DOCKET 50-255 - LICENSE DPR-20 -
PALISADES PLANT - SEP TOPIC VI-4, CONTAINMENT ISOLATION SYSTEMS

PALISADES PLANT

Additional Comments on NRC Evaluation of

SEP TOPIC VI-4

PEN 17 SCHEMATIC
FOR LLRT

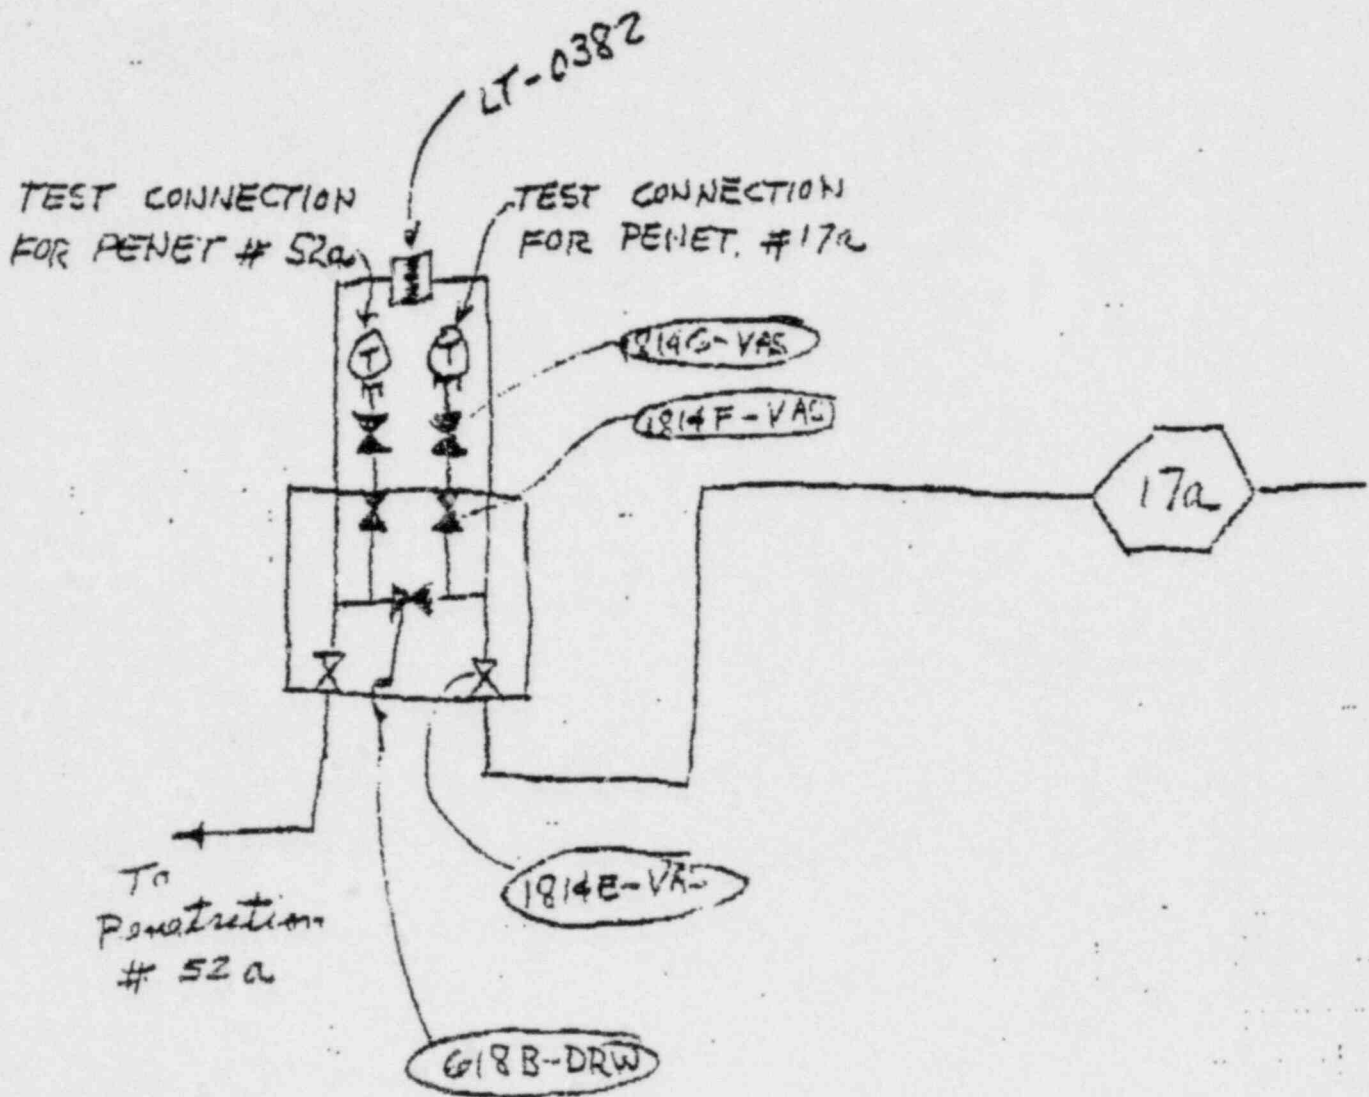
3. Penetration 17 and 17a - Attached is a sketch showing the configuration of these penetrations following recent plant modifications. Previous NRC concerns are no longer applicable.

PENETRATION 21

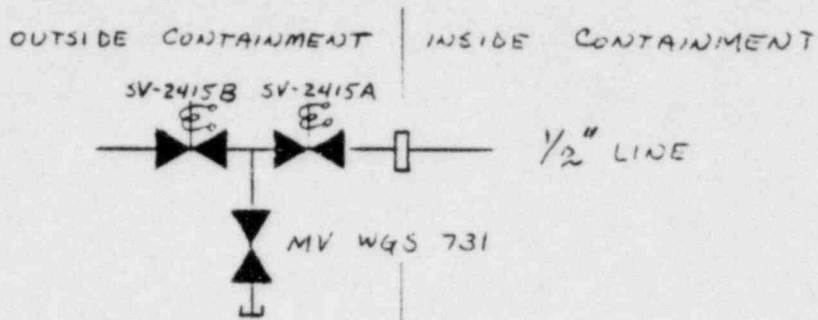
4. Penetration 21 and 21a - Attached is a sketch showing the configuration of these penetrations following recent plant modifications. Previous NRC concerns are no longer applicable.

PEN 28 SCHEMATIC
FOR LLAT

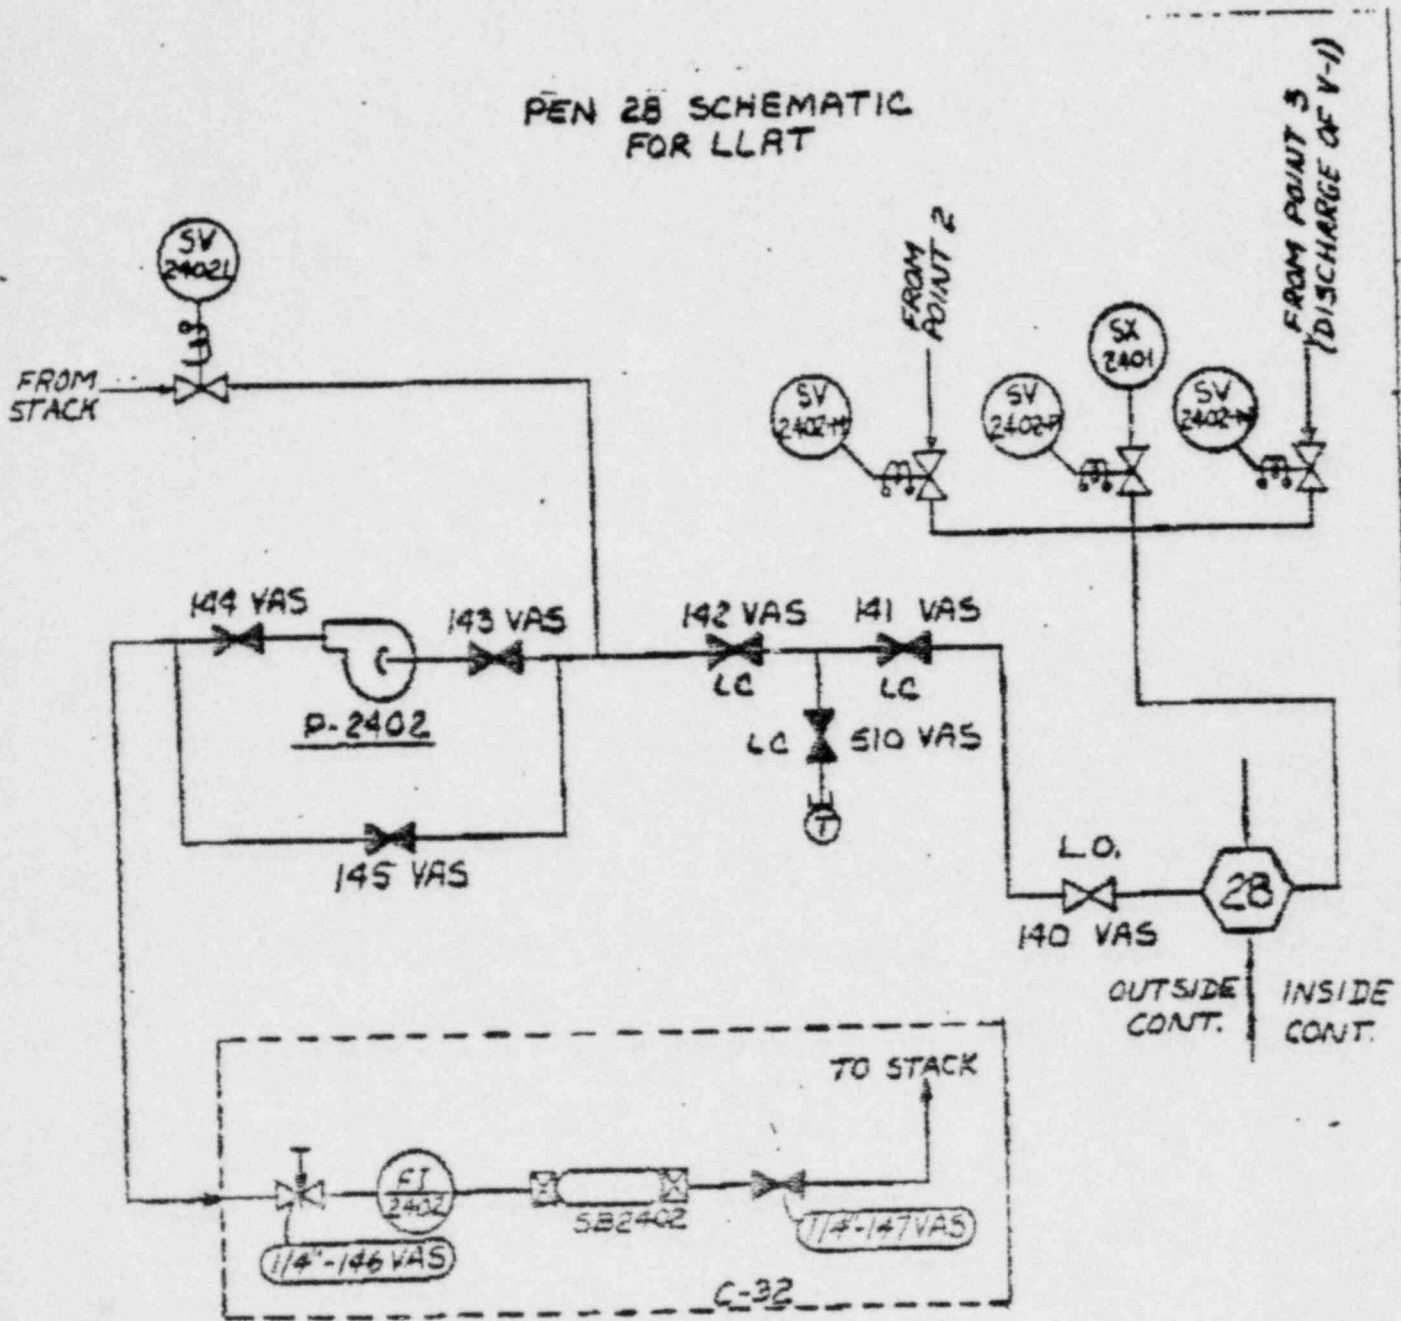
7. Penetration 28 - Attached is a sketch showing the configuration of this penetration following recent plant modifications. Previous NRC concerns are no longer applicable.

PEN. 48 - SCHEMATIC FOR LLRT
 (ALL VALVES ARE VAS VALVES)

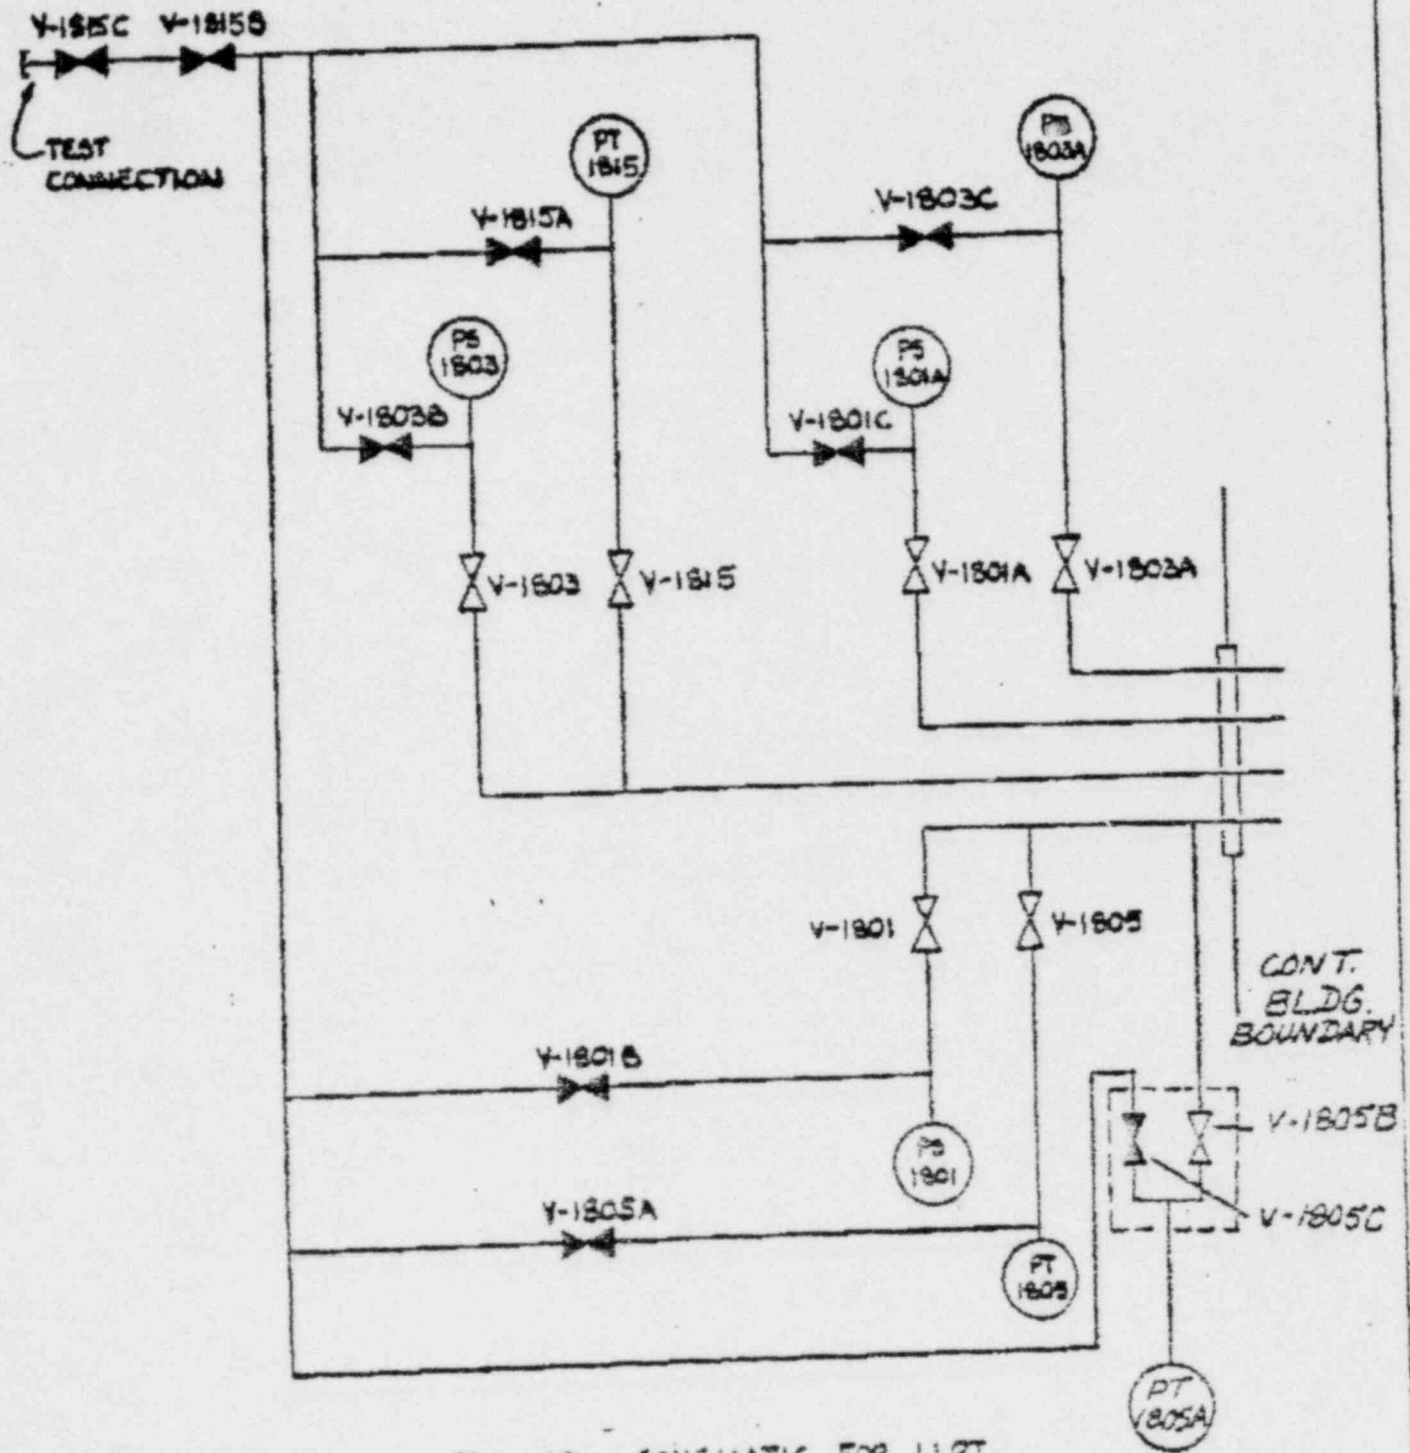
10. Penetration 48 - Attached is a sketch showing the configuration of this penetration following recent plant modifications. Previous NRC concerns are no longer applicable.
